SERVICE BULLETIN MAINTENANCE OF WAY EQUIPMENT

DATE:	2-11-2003			BULLETIN NO:	03-003
TITLE:	LINING MASK LINEAR ACTUATOR SERVICE INFORMATION				
RATING:		DIRECTIVE (Action Is Required)		ALERT (Potential Problem)	
	X	INFORMATION (Action Is Optional)		PRODUCT IMPROVEMENT (Enhance Product)

PRODUCT SERIES / MODEL: 6700 Tampers

1. EXCESSIVE HUNTING - See Figure 1

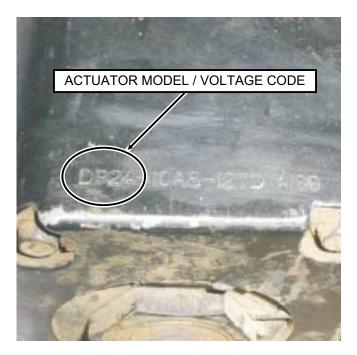
Verify that the actuator voltage rating is compatible with the design specification. HTT units are intended for operation on a 24 volts DC control circuit. Units rated for less than 24 volts will spin faster than intended, take longer to stop spinning when power is removed, and result in the mask "overshooting" the correct position. It then has to reverse direction to obtain the desired position, only to overshoot again. This overshoot and reverse cycling, called "hunting", causes premature gear and ball assembly wear, electric motor temperature rise, premature motor brush / armature wear, and potential motor burnout.

To check the actuator motor voltage rating, find the manufacturer's model code, located on the end cover (housing the feedback gears and potentiometer). On one side should be listed a 16 digit code, in groups of four, separated by spaces or dashes. The leading or 1st four digits designate the model and voltage rating, and should read "DP24" as shown in Figure 1.

Units that do not match the "DP24" model / voltage rating should be removed from service immediately.

FIGURE 3

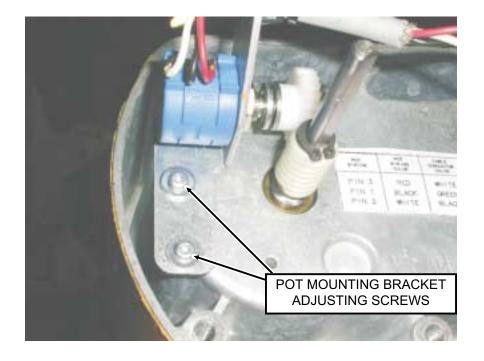
The actuator calibration is dependent on proper feedback from the actuator position feedback potentiometer. This "pot" incorporates a drive pinion gear that meshes with a worm gear attached to the end of the ball screw. The drive pinion gear seated on the "pot" is a slip-clutch design to prevent potentiometer damage in the event that the gear is rotated beyond the limits of the pot stroke.

There have been instances where the clutch mechanism has exhibited slip (and subsequent loss of calibration) when in side-loaded conditions. This can be caused when the mounting bracket has been adjusted to remove all backlash, and then tightening the mounting screws forces the gear even closer, so that there is excessive side load on the gear. The side load can bind the pot shaft enough to exceed the clutch slip force, so the pot gear turns, but not the shaft. This throws off the actuator calibration.

HTT recommends that the pot mounting bracket be adjusted so that the pot gear has a very minimal amount of backlash, with no axial force generated on the pot shaft. You should be able to rotate the pot gear a very slight amount when rocking it by hand while it is meshed with the worm gear. This will prevent side loading of the shaft, which can cause the pinion gear to turn on the pot shaft during normal operation, and affect the calibration of the lining mask actuator. To adjust, loosen the two mounting screws holding the pot bracket, and position the pot gear on the worm gear so there is slight backlash (making sure the pot gear is also centered over the worm gear). Then, carefully tighten the screws, and re-check for the slight amount of backlash when completed.

FIGURE 6

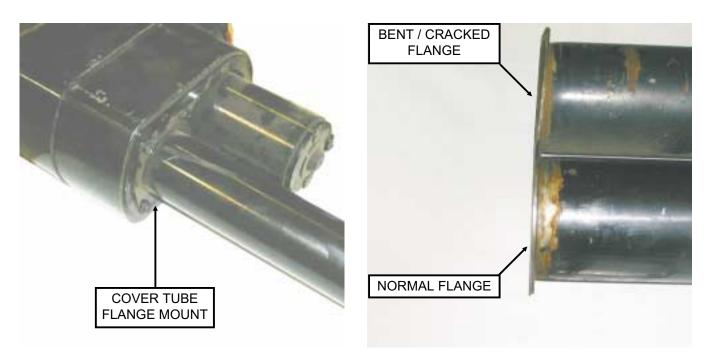
In June of 2001, HTT Engineering implemented a change in the purchase specification for the Lining Mask Actuators. This was done to correct problems reported where the cover tubes were bending, cracking, and/or breaking at the mounting flange. (Bending has been attributed to extreme side force, such as mask follower derailment). The new specification calls for a thicker wall material to be used, making the flange area structurally more robust. The new thicker-wall cover tube (HTT Part # 2004471) is not directly compatible with older units (rod seal diameter is different than older units), and both the screw assembly and the cover tube must be replaced at the same time when rebuilding. See the Service Parts List included in this Service Bulletin for the "Kit Option" part number to use when rebuilding older lining mask actuators.

Cover Tubes may be inspected and replaced by removing the 4 flange mounting plate bolts, and then sliding the tube off the extension rod assembly. Inspect the flanges for cracks at the bend on the inside corner of the flange, and also for signs of bending or distortion of the flange itself. Replace any cover tube showing any signs of damage. When re-installing the cover tube, make sure the gasket is in place and properly seated under the flange mounting plate.

FIGURE 8

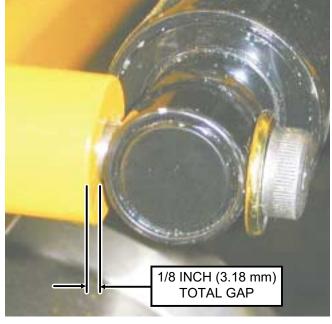
Note: All actuators of HTT origin distributed with the thick-wall cover tube after June 2001 can be identified by the presence of the letters "12PJ" in the 3rd group code stamped on the actuator cover as shown in Figure 8.

Also noted during investigation of tube failures was the potential for binding the extension rod when mounting the units to the mask assembly. The original design called for a flat washer to be used on both sides of the extension rod when installing the shoulder bolt that holds the rod to the mask assembly. This can, in some instances, captivate the extension rod, causing binding that can help contribute to tube failures. Current design specifies only one washer to be used. This allows some free play (float) in the lateral direction, and keeps the end of the extension rod from being "clamped" in position during extend/retract cycles.

With the washer installed on the bolt head side, the actuator rod should be centered on the shoulder bolt diameter, and free to move about 1/16 inch (1.59 mm) in either direction, and not pressed to one side in either direction. If the actuator is pressing against the flat washer installed toward the head of the shoulder bolt, and cannot freely move toward the mounting post, remove the shoulder bolt, install the flat washer on the <u>post</u> side of the rod, then re-install the shoulder bolt using Loctite 242 (Blue). Check the alignment of the rod on the shoulder bolt diameter, making sure it has freedom to move the 1/16 inch (1.59 mm) in each direction, for a total movement amount of 1/8 inch (3.18 mm).

5. LINING MASK ACTUATOR CALIBRATION - See Figure 10

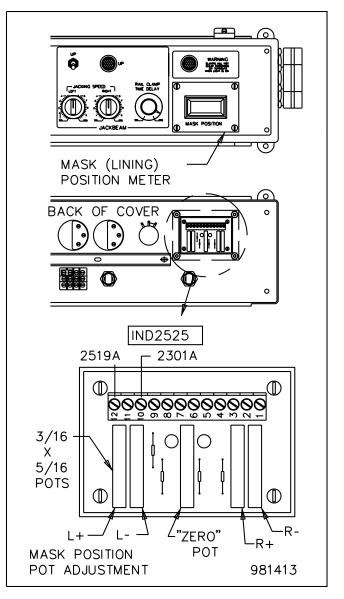
- 5.1 Disconnect rod end of actuator from mask assembly.
- 5.2 Run actuator to full extension, then allow rod to rotate for approximately 10 seconds to set pot gearing and pot stroke correctly. (This sets the pot at full travel position with full screw extension, and sets the total pot adjustment range to be within total actuator screw stroke).

- 5.3 Re-connect rod end to mask assembly, then retract rod fully. **Do not let the rod rotate during retraction by not mounting it up first!** (This would change the pot setting from the full-extension value just set, and make calibration very difficult, if not impossible, without repeating the entire procedure).

- 5.4 Using mask position switch, position mask at 8.00 inches from "Unity" mark established during Lining Unity Calibration (See Section 6.5.4 of the Operator's Manual). Accurately measure (to the nearest tenth of an inch) the position using a tape measure or scale.

- 5.5 Calibrate the Lining Mask Position Meter by measuring the actuator feedback with a voltmeter, reading between terminals 10 and 12 (wires #'s 2301A and 2519A),

located on the back of the lining mask position meter. Adjust the "Zero" pot to read the same as the feedback voltage to the nearest tenth of a volt.

5.6 Retract mask 1.5 inches from the Unity mark, by accurately measuring (nearest tenth) the distance from the "Unity" mark with a tape measure or scale.

Refer to Figure 11 for wiring and connection information.

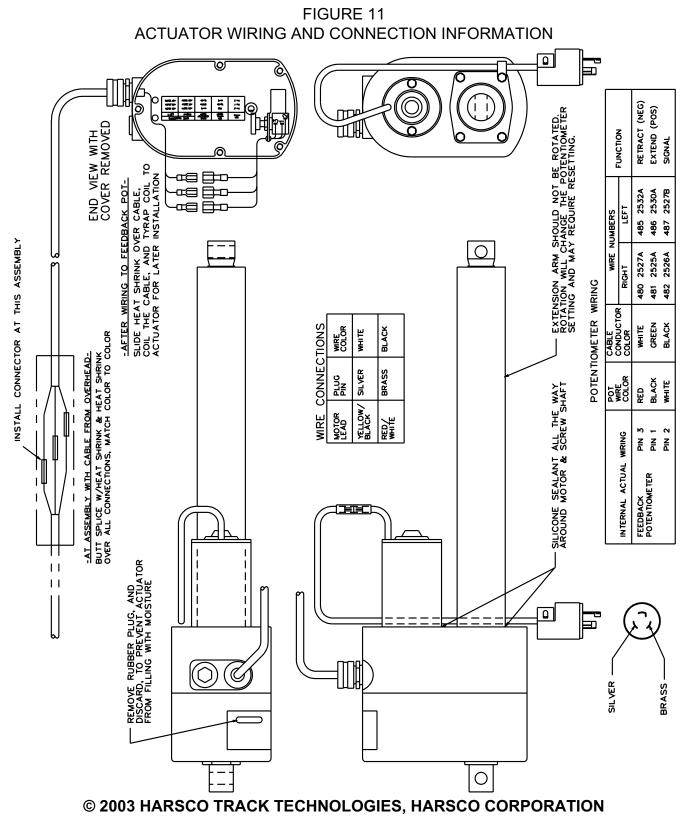
Installation Notes
